# Hanson Bass Point Quarry Project | April 2017

SECTION 75W PLANNING ASSESSMENT REPORT  
MODIFICATION 1 (PART A)- MAJOR PROJECT  
APPROVAL 08\_0143- OFFICE RELOCATION

Figure A1: Extraction Area and Site Features

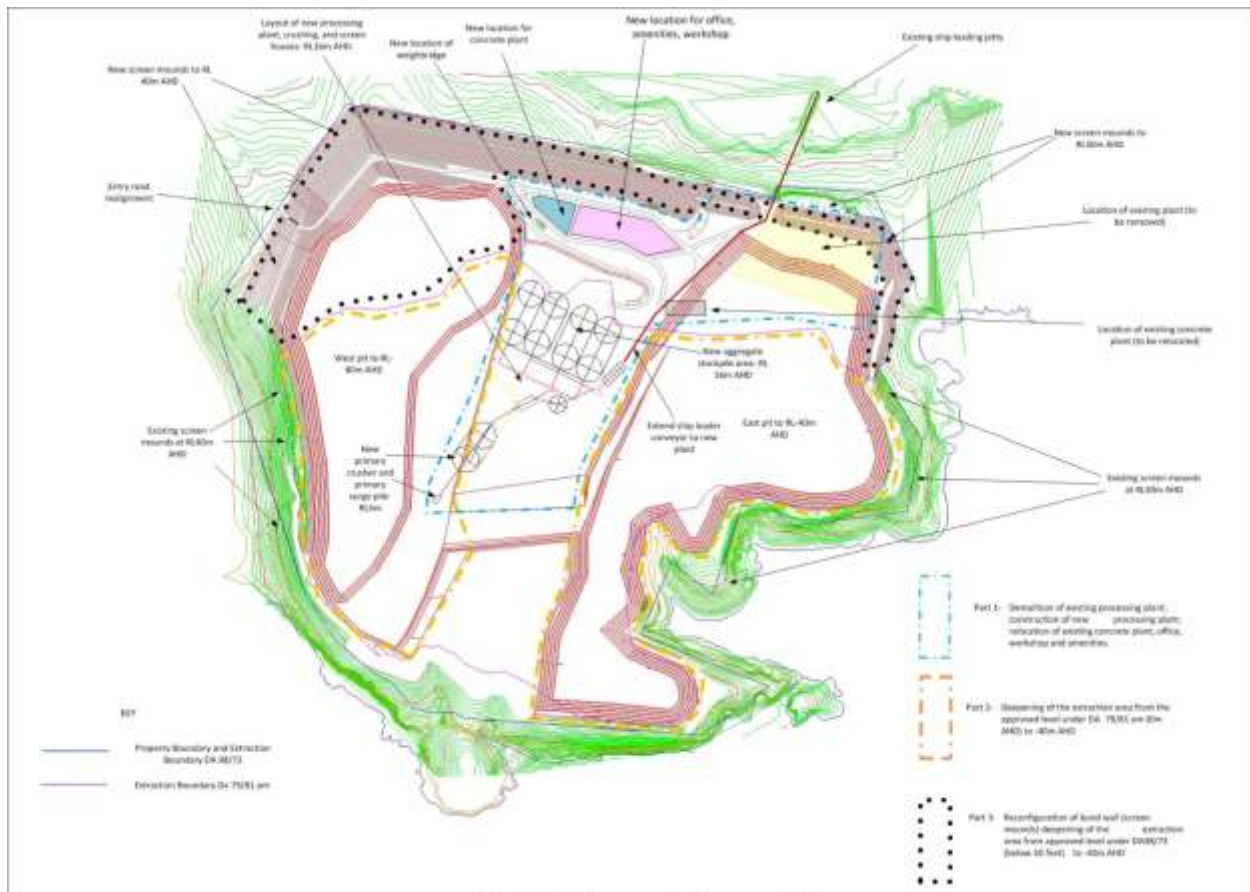
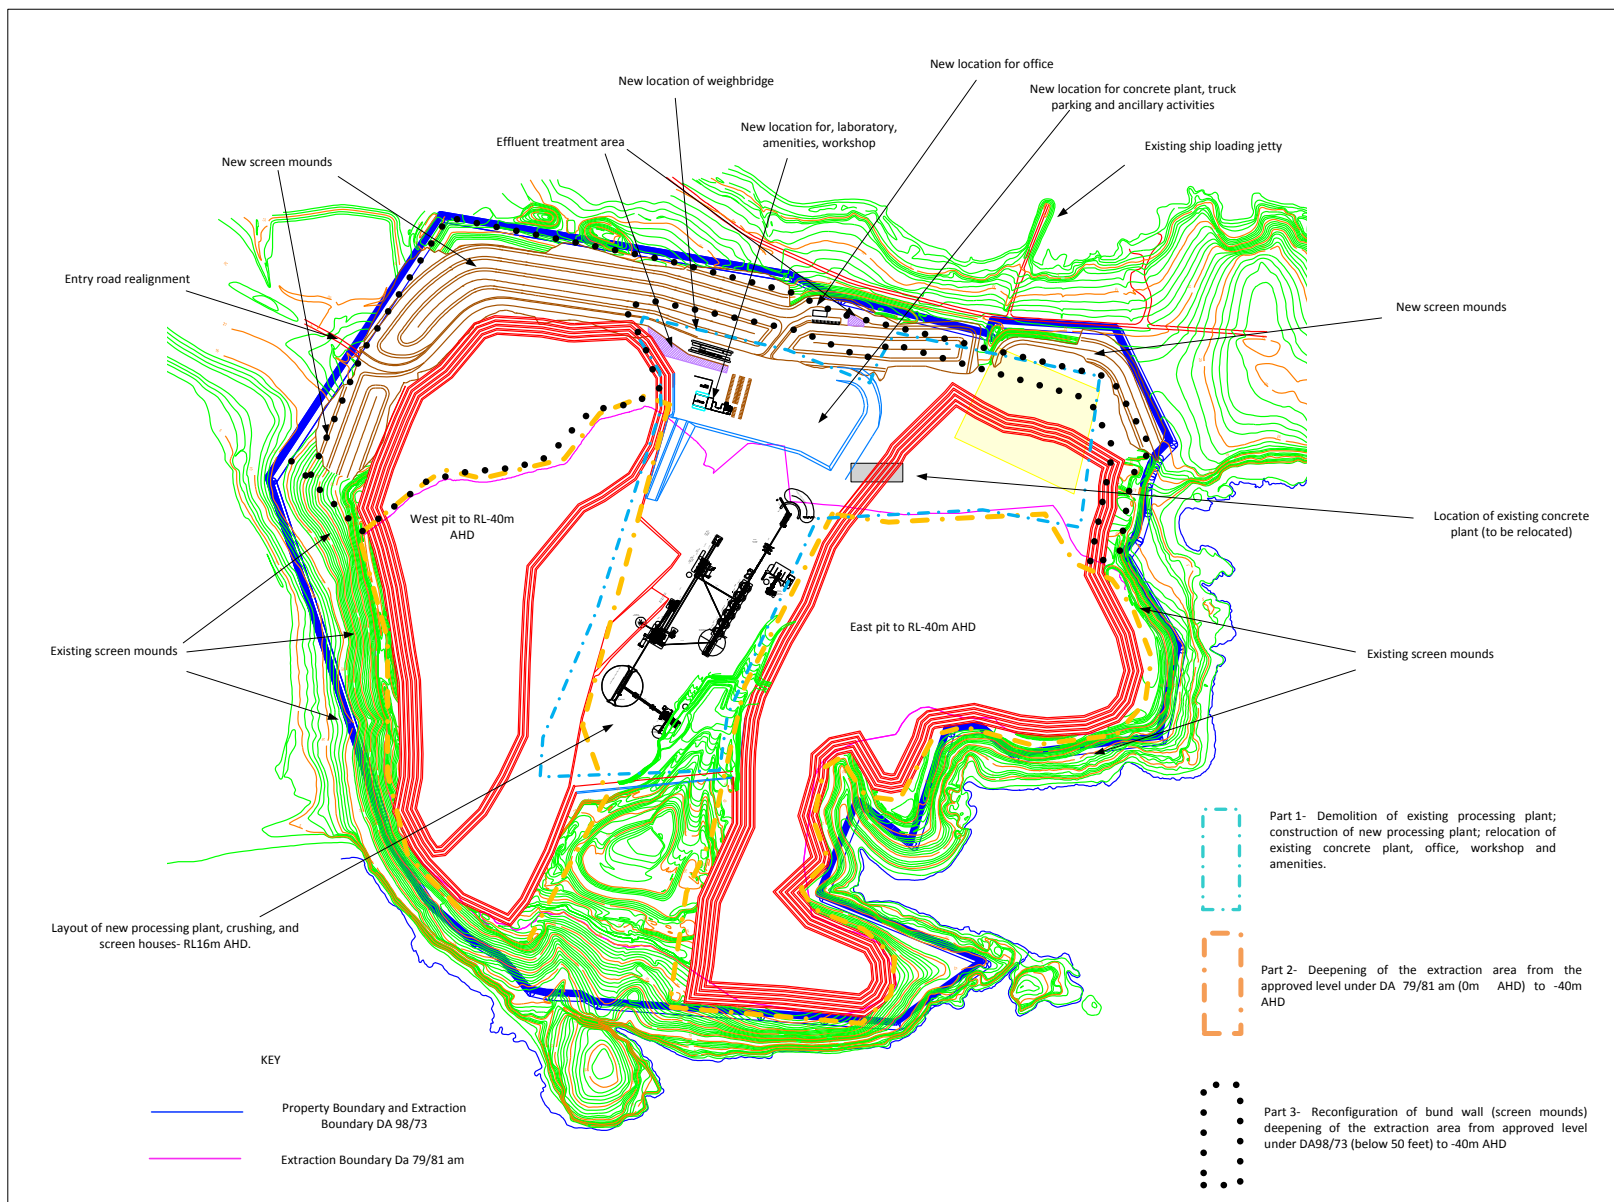
Replace;

With;

The proposed modification does not seek to alter the footprints of Part 1 or Part 2 of the existing Figure 1 in Appendix A, nor does it seek to alter the footprint of Part 3. The modification merely seeks to relocate the position of the office as shown on Figure 1 approximately 120 metres to the north.

To achieve this, the reconfiguration of bund walls (screen mounds) as shown on Figure 1 in Appendix A will require amendments to allow for:

1. Level pad on which to build the office and amenities.
2. Access road across the bund to the office and amenities.

A level pad will be required to accommodate the office. It is proposed that the pad is situated on the approximately 120 metres to the north of the current locations as shown on figure 1 in Appendix A.

The pad will be located at RL30m AHD and be nestled into the northern face of the screen bund and will be screened predominantly by the existing vegetation.
